MMN Building AHU 4 January Report

AHU_4 (VAV)

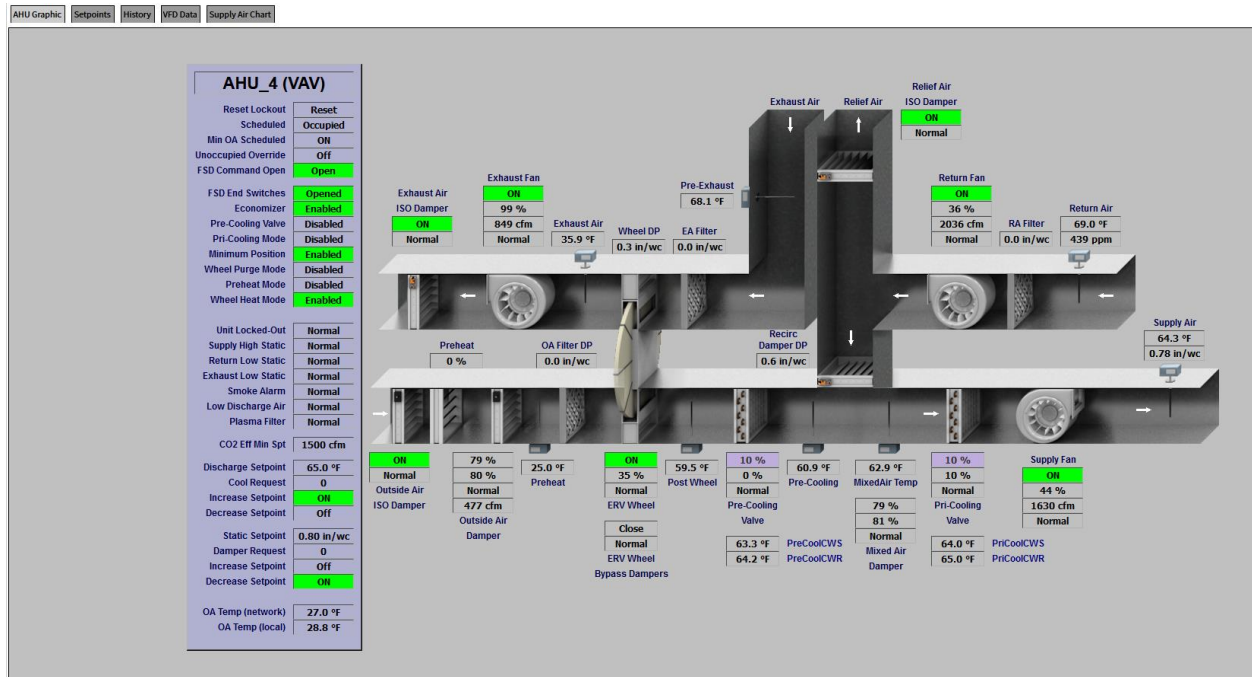
- Verify chiller plant doesn't run in the winter as shown in FC 8 something looks odd where it appears at time the difference between the supply and mixing temperature large like mechanical cooling is running.
